# **NTTA ALTERNATIVE 3C VERSUS THE BALANCED VISION PLAN**

**PREPARED BY THE TEN PRESIDENTS**

**17 FEBRUARY 2015**

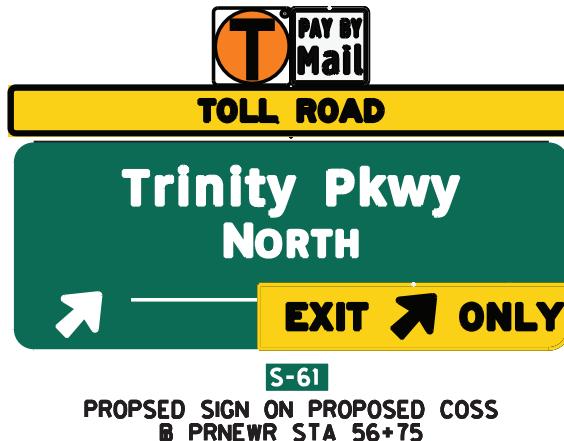
Compare these inspirational images to this dreary image offered by NTTA of Alternative 3C. Note as well that none of the exit and entrance ramps indicated on NTTA's plans are illustrated here, some of which will soar 20 or more feet above the adjacent levee (already 30 feet high) on their way to connect to the Continental Bridge and elsewhere.

Section through northern Parkway (SH-183 to Continental Avenue)  
Flipped for comparison (refer to NTTA Trinity Parkway Roll 02)

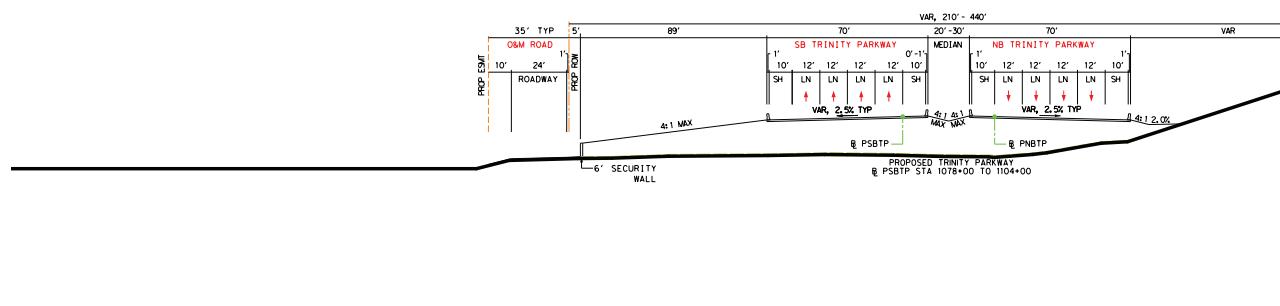
In addition, however, there are key dimensional differences between the Balanced Vision Plan and NTTA Alternative 3C. Most critical among these is simply the intrusion of Alternative 3C into the Trinity Park and floodway by up to 290 feet more than was envisioned in the BVP.

- North Section (SH-183 to Continental) up to 290 feet
- Central Section (South of I-35 E ) up to 198 feet
- South Section ( South of I-35 E) up to 246 feet

Section through Parkway at Downtown

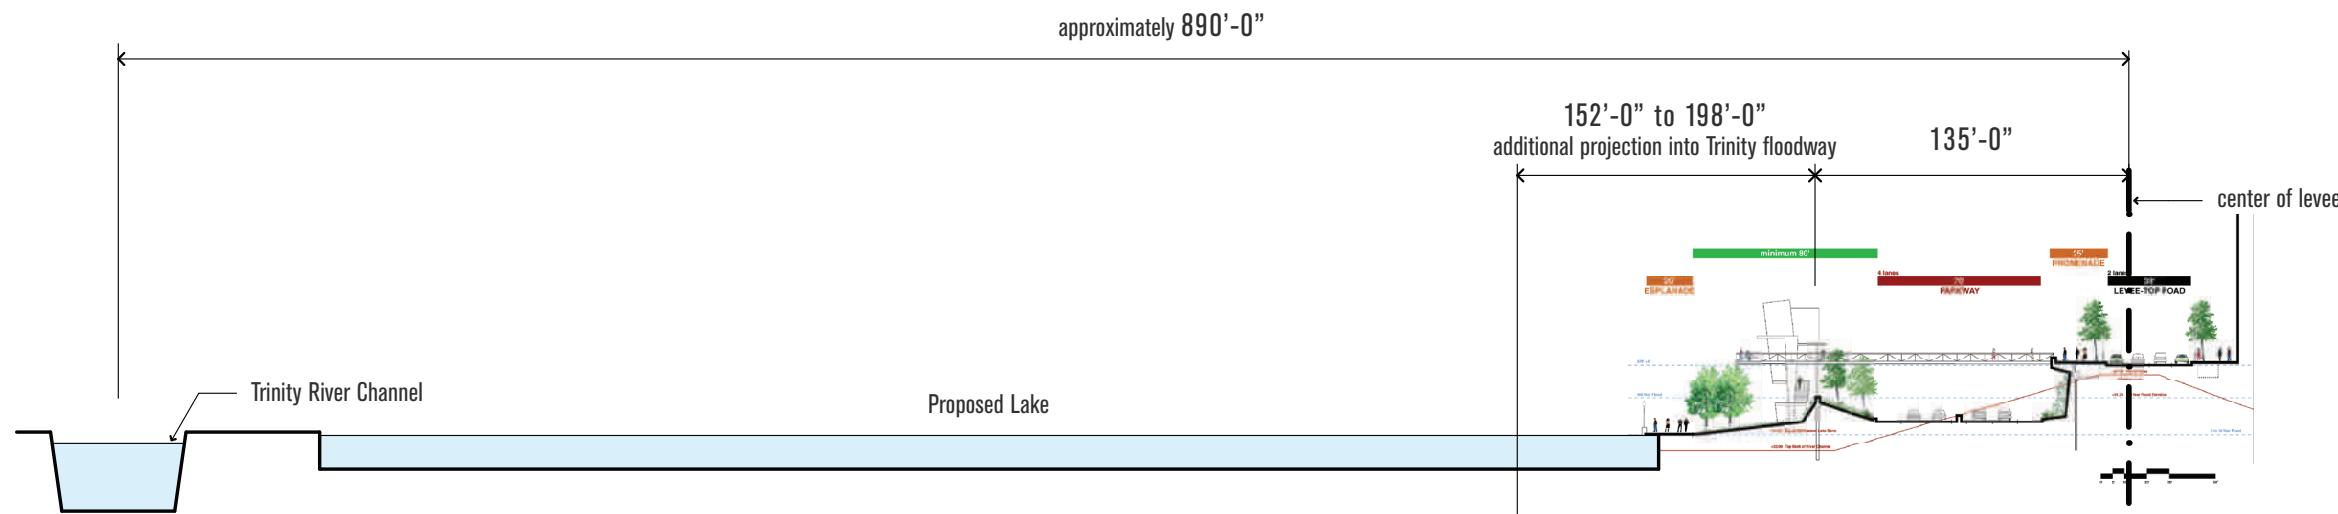
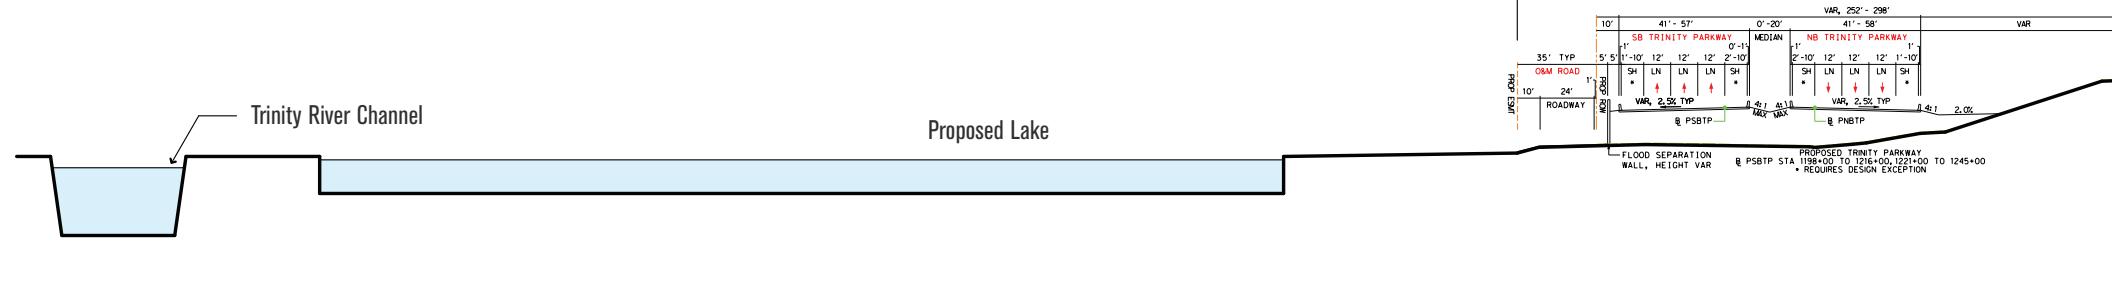
Note: Lake configuration related to Alternative 3C has changed from that shown in Balanced Vision Plan

## Section through parkway at Downtown

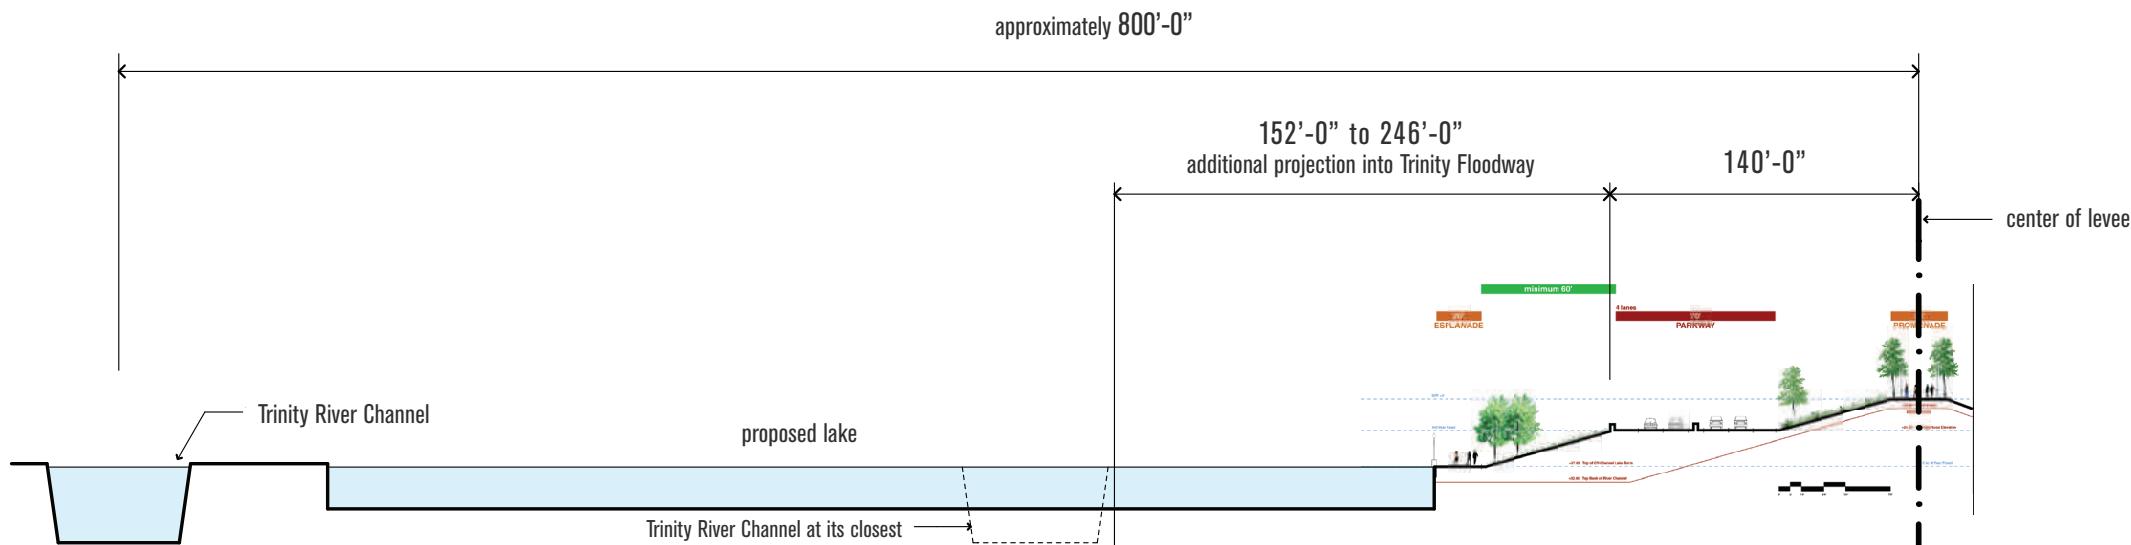
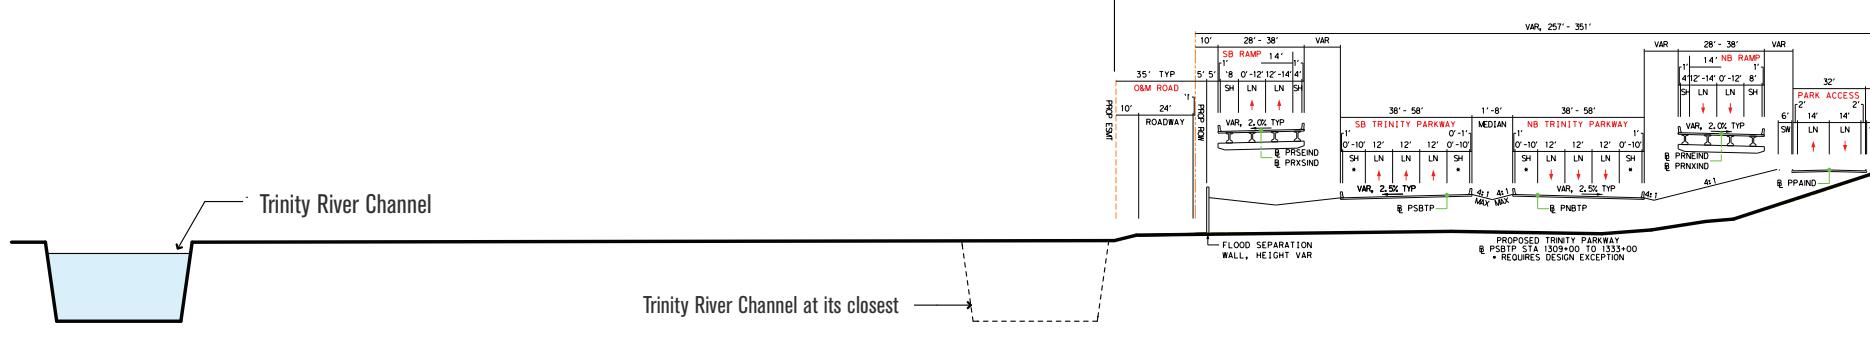
Note: Lake shown in BVP has been eliminated as related to Alternative 3C

**TOLL ROAD PARKWAY INSIDE LEVEES APPROXIMATELY 6.10 MILES**

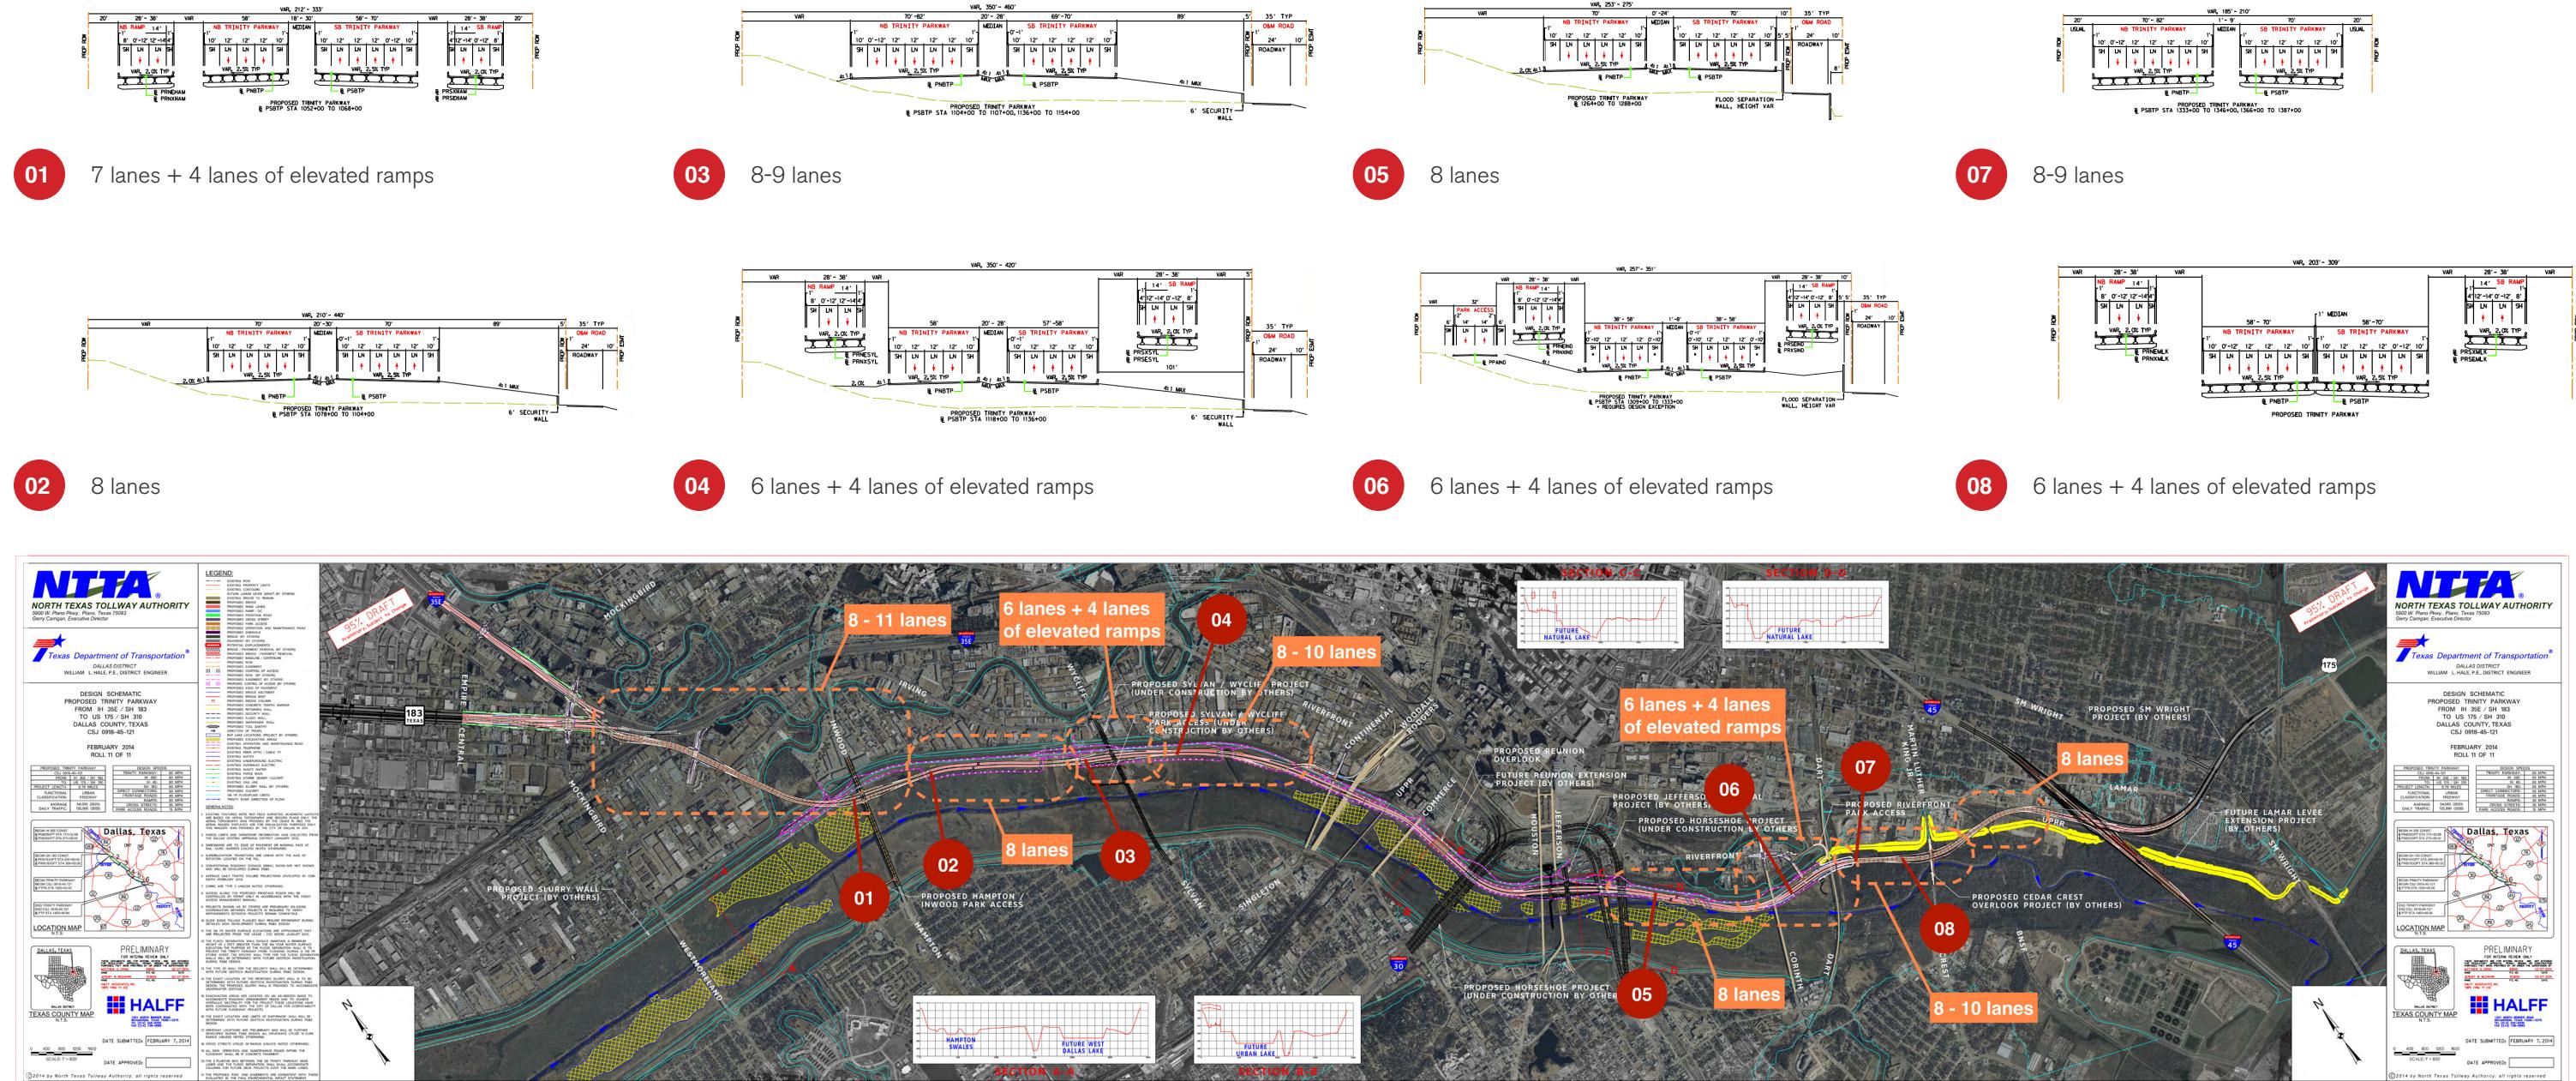
The NTTA Alternative 3C drawings illustrate up to 11 total lanes (12 feet wide). These lanes are extensive, to the degree that over 40 percent of the toll road inside the levees is shown at 8 lanes or more. This does not include the additional 2 lanes of the O&M Road required for maintenance of the flood wall.

**TOLL ROAD PARKWAY WITH 8+ LANES APPROXIMATELY 2.66 MILES OR 43% OF LENGTH**

**DOES NOT INCLUDE O&M ROAD AT FOOT OF FLOODWALL, WHICH ADDS 2 MORE LANES (24')**
